ADDENDUM NO. 01

MADISON CENTRAL HIGH SCHOOL BASEBALL FACILITY

Madison, Mississippi
WBA Proj.# 2416

3
S3.2
COLUMN BASE CONNECTION - BUILT-UP COLUMN
1 1/2" = 1'-0"

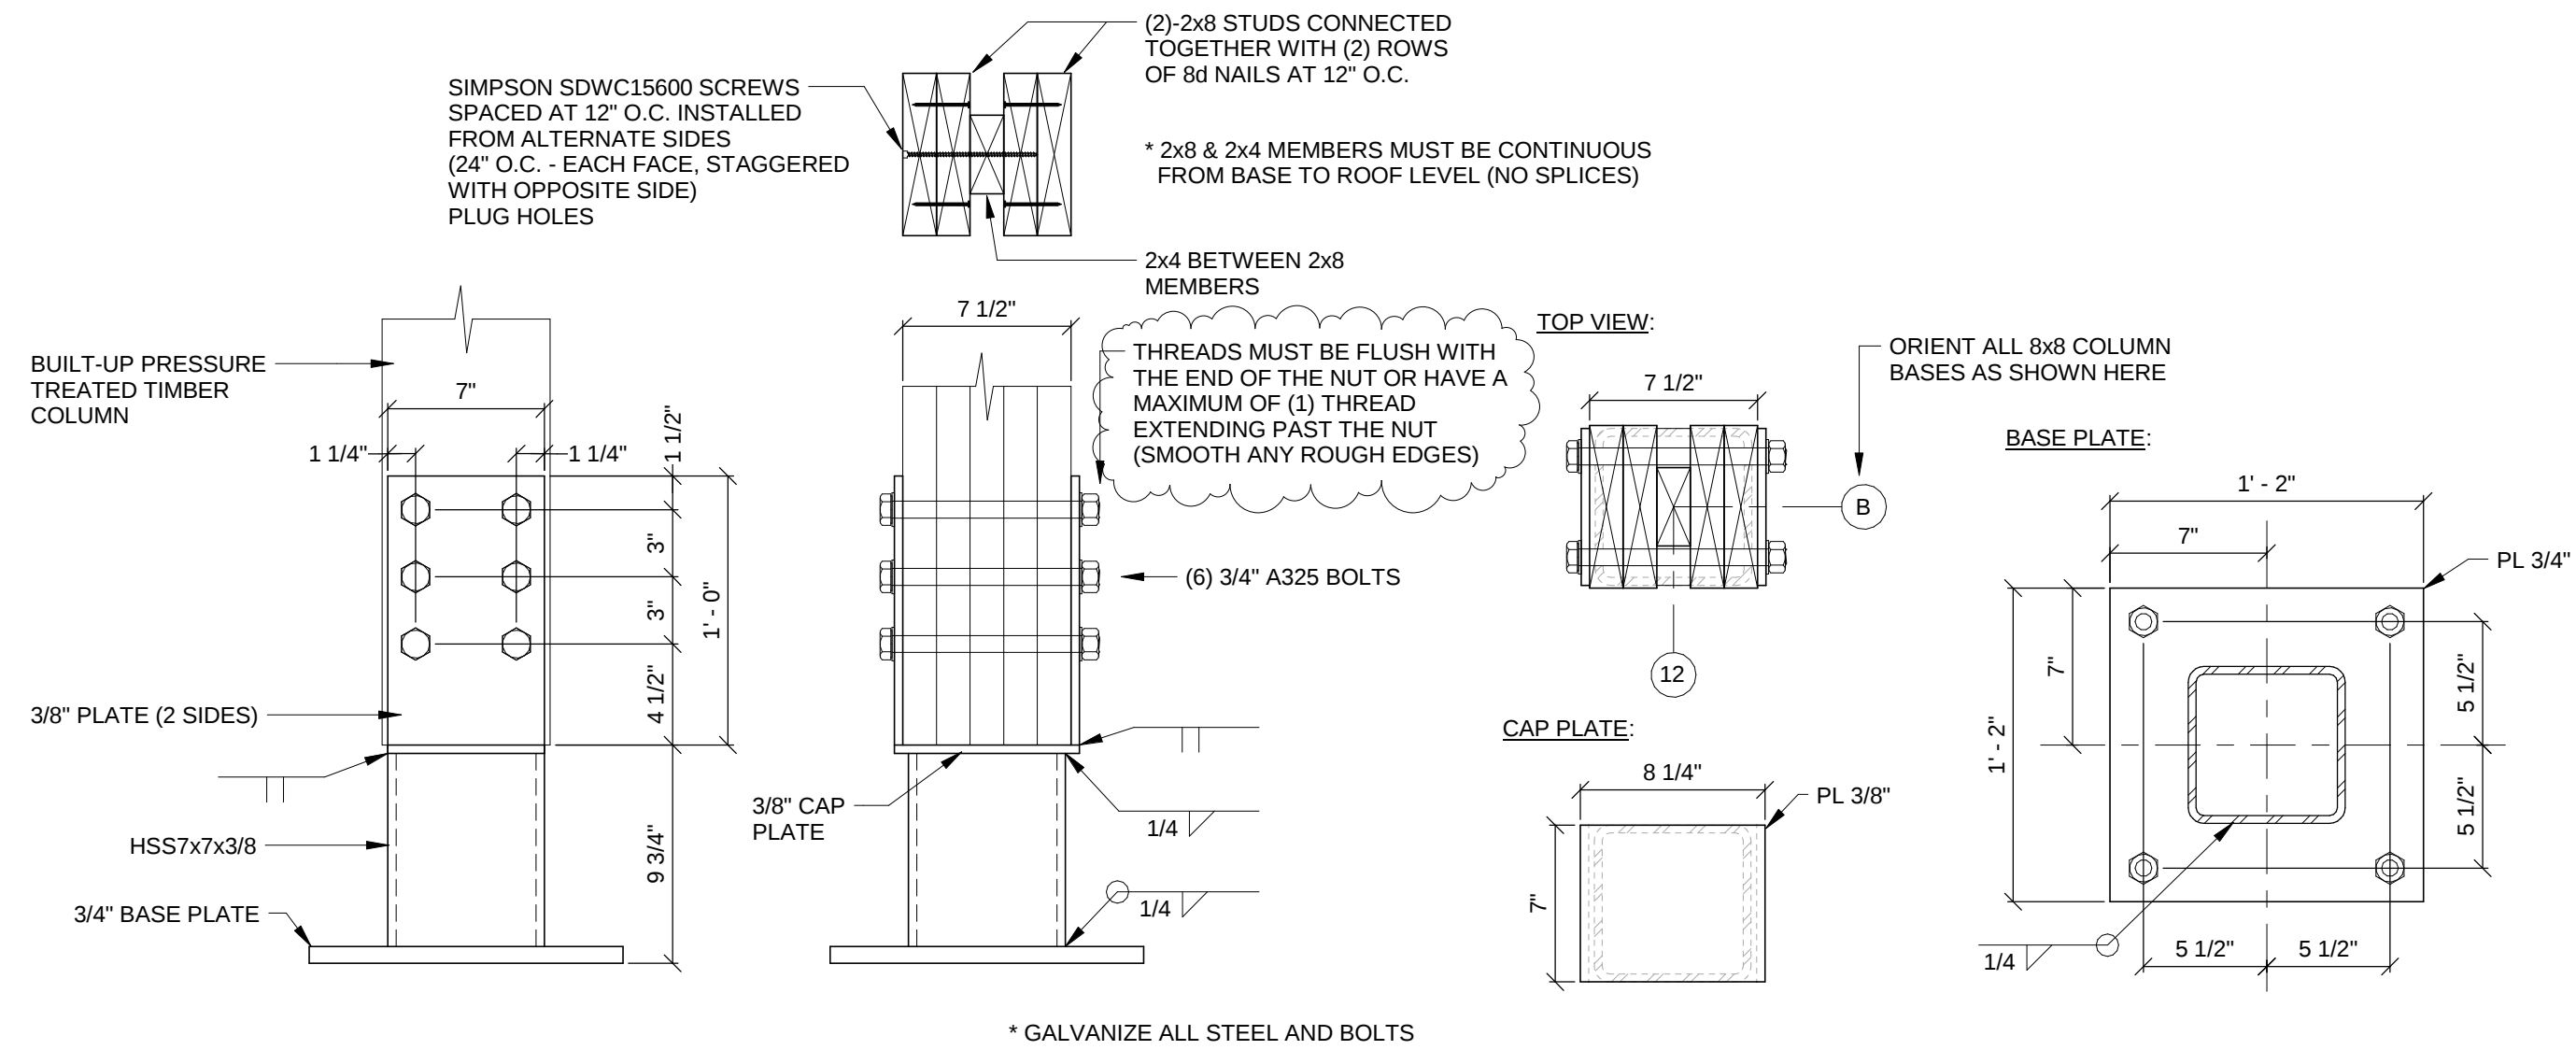
REVISE details 1, 2, & 3 to limit thread extension past nut, per enclosed revised sheet S3.2

5
S3.2
COLUMN BASE CONNECTION - 6x6
1 1/2" = 1'-0"

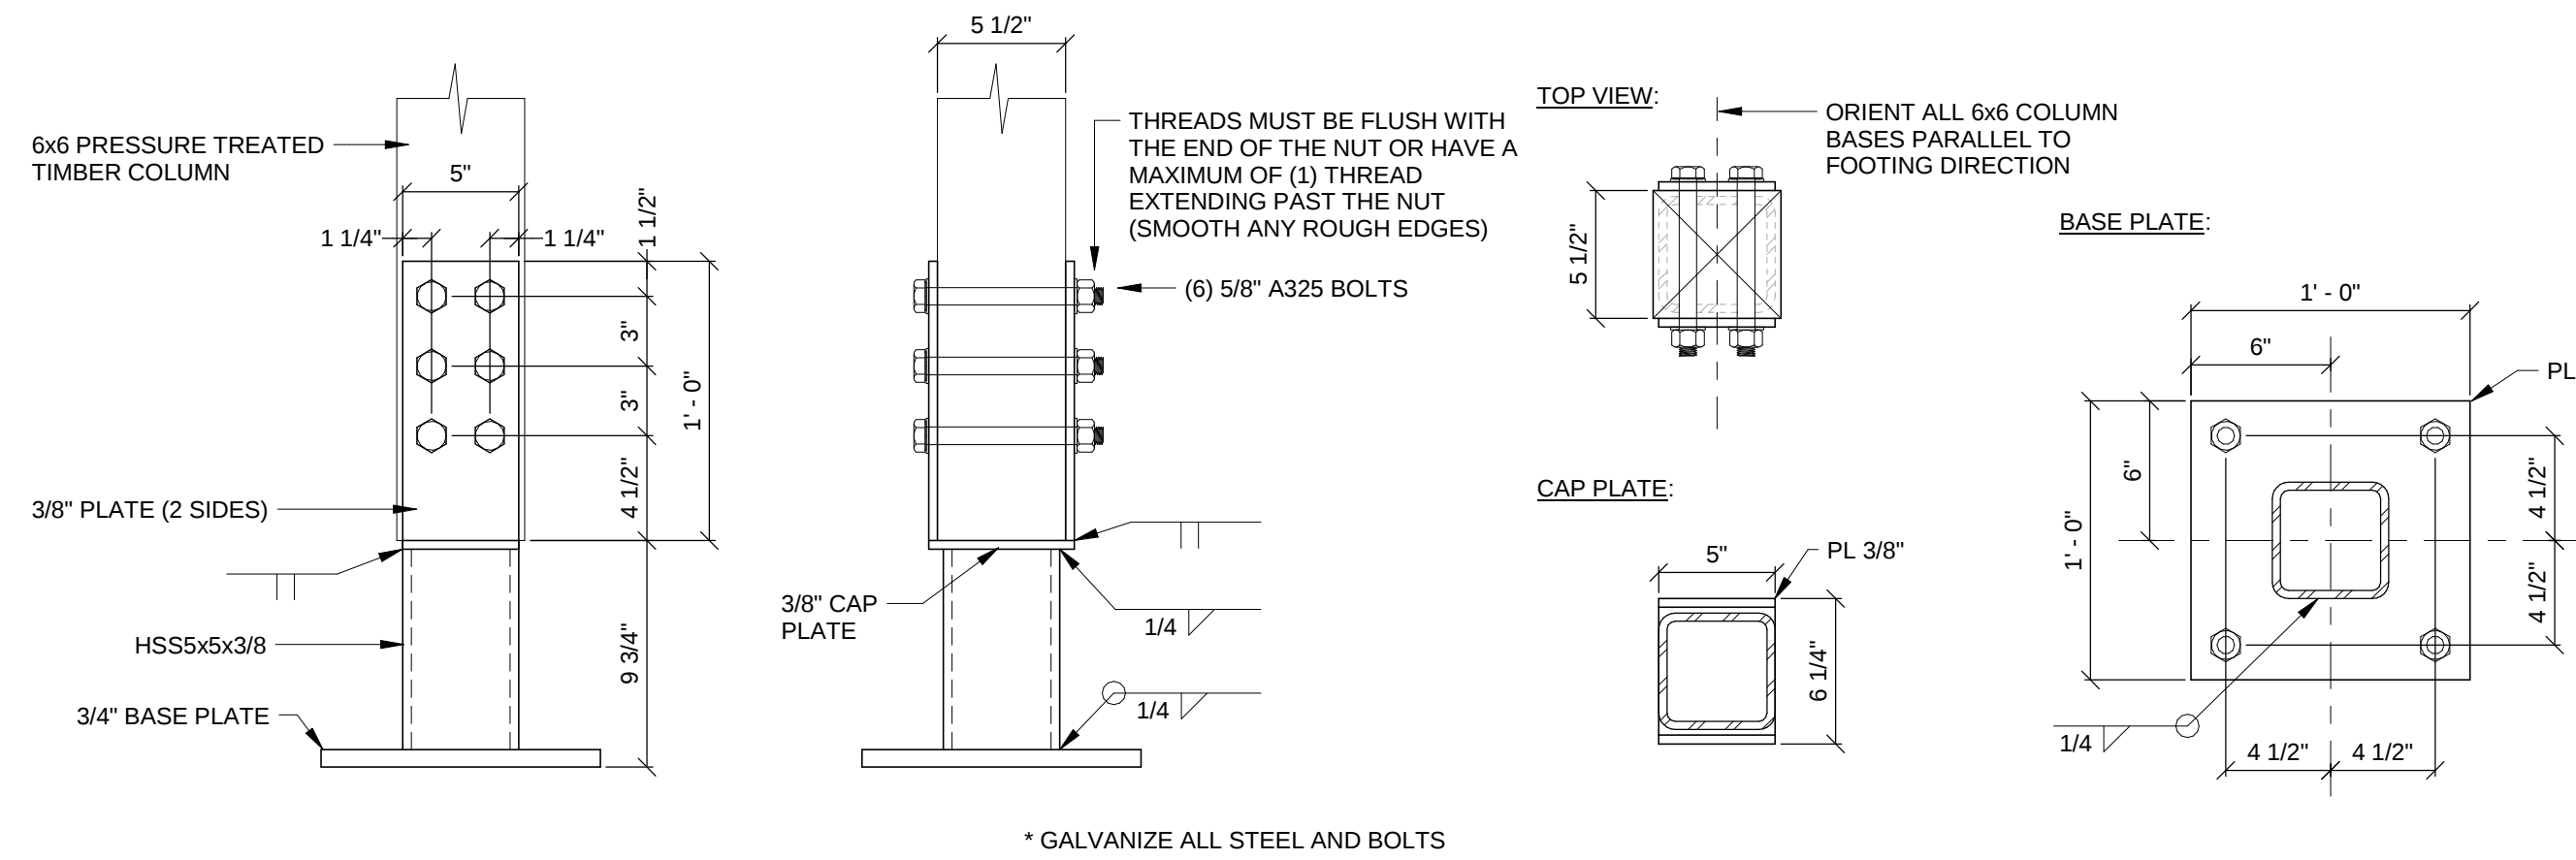
ADD column and beam connection details 5, 6, 7, 8, & 9, per enclosed revised sheet S3.2
